BEFORE THE
PUBLIC SERVICE COMMISSION OF WISCONSIN

Application of Wisconsin Public Service Corporation for Authority to Construct and Place in Operation a New Multi-Pollutant Control Technology System for Unit 3 of the Weston Generating Station, Marathon County, Wisconsin

Docket No. 6690-CE-197

Direct Testimony of Jeremy Fisher, Ph.D. On Behalf of Clean Wisconsin

Figure 4. Difference in capacity between Future 7, Scenario CW1 (Weston 3 replaced with no [redacted]) minus Future 7, Scenario 1 (ReACT installed).

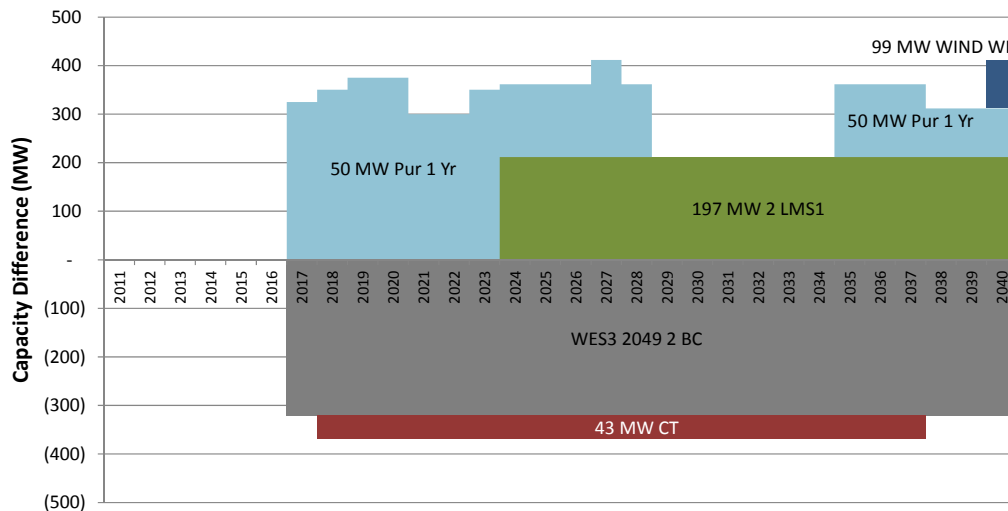
Clean Wisconsin asked the Company to run an EGEAS scenario in which the [redacted] is not forced into the model (Data Request 4-CW-1). The Company provided runs for Futures 4, and 7-9. The capacity result of this model run in Future 7 is shown in **Figure 4**, below.
